IN THE MATTER of Proposed Plan Change 5 to the Operative Hamilton
City District Plan

**REBUTTAL STATEMENT OF EVIDENCE OF ALASTAIR JAMES BLACK
(TRANSPORT)**

Dated 22 September 2022

Figure 1: Peacocke Public Transport Access map (source: evidence of Mr Carnell)

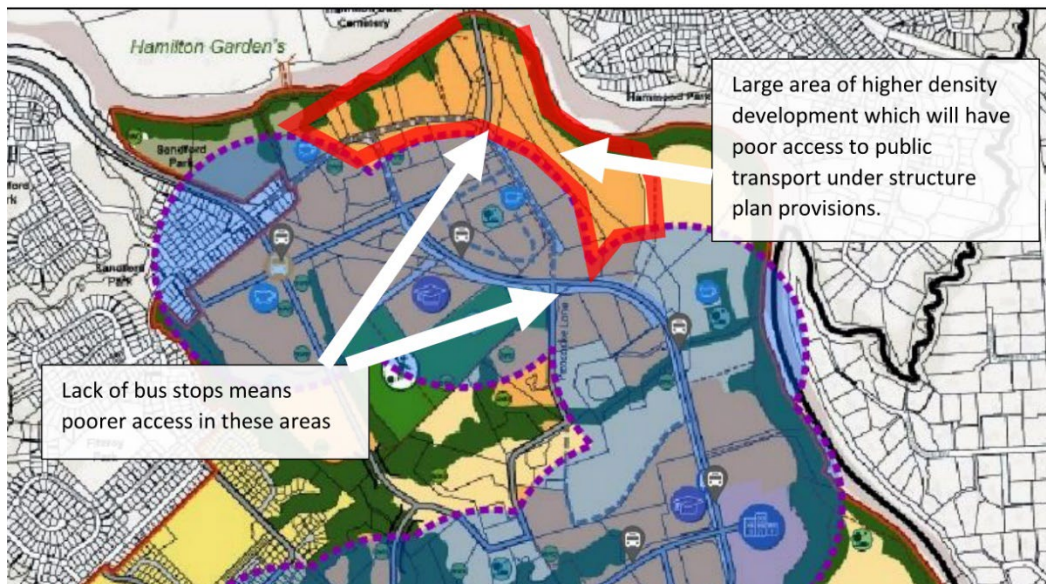
24. For the reasons set out in my primary evidence¹⁷, I disagree with Mr Carnell¹⁸ and Ms Craven¹⁹ on whether a bus stop should be shown where Weston Lea Drive is severed.
25. Approximately half of the area shown by Mr Carnell as 'poor access to public transport' is consented as a retirement village. The extent of the retirement village site is shown in my primary evidence²⁰ and I have shown it on Mr Carnell's figure using light green shading and added the access points as yellow stars. In my assessment two of the three retirement village accesses are with a 600m walk to bus stops. The third access is a secondary access to the dementia and hospital unit.

26. I do not support including a bus stop on the major arterial because:
- a) Much of the potential catchment east of the major arterial has been consented as a retirement village (including a dementia and hospital unit).

- b) The retirement village has two accesses within a 600m walk of a bus stop.
 - c) The catchment west of the minor arterial is limited in size and the land uses include proposed natural open space and the HCC water treatment plant.

- d) This section of the major arterial is under construction and safe pedestrian access to/from the stop would likely require an underpass to be constructed. I am not aware of any proposals to provide an underpass in this location, meaning that retrofitting at significant cost would be required.

- e) The other bus stops shown have a higher degree of certainty compared to Mr Carnell's proposed bus stop. For example the stops on the minor arterial are included in the construction drawings for Peacockes Road and Whatukooruru Drive.

27. Mr Carnell²¹ and Ms Craven²² seek an additional bus stop on the minor arterial near the intersection with Peacocke Lane. Figure 2-2 identifies Peacocke Lane as a 'Proposed Public Transport Route'. I expect that bus stops will be provided on Peacocke Lane to serve the area south-west of the minor arterial that Mr Carnell has identified as having 'poorer access'. I consider that this will achieve the outcome sought in the P13 of the Regional Passenger Transport Plan. I do not support the introduction of a additional bus stop at this location.
